Access Compliance Report

Public Rights-of-Way

(Pedestrian Signals)

Intersection ID: N/A	Main Street:	Cross Street: N/A	Location: N/A
ADA ID: F3675D36BC08	Signal Type: One Push Button-APS	Overall Compliance: No	Severity Score: BTN 1: N/A BTN 2: N/A No BTN: N/A
Codes/Mitigation Info/Possible Solution		Field Measurements/Component Compliance

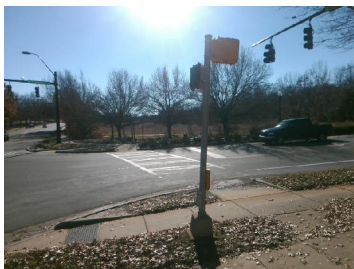
Yes B 1 Clear Xing Direction?	ClearlyMarked	N/A B 2 Clear Xing Direction?	N/A
B 1 Crossing Direction	To S	B 2 Crossing Direction	N/A
Yes B 1 DistanceTo XWalk (in)	53.0	N/A B 2 DistanceTo XWalk (in)	N/A
No B 1 DistanceTo Curb (in)	142.0	N/A B 2 DistanceTo Curb (in)	N/A
Yes B 1 Diameter (in)	2.0	N/A B 2 Diameter (in)	N/A

Possible Solutions: Replace Signal Push Button With APS Button on New Post. Remove & Relocate Sign.
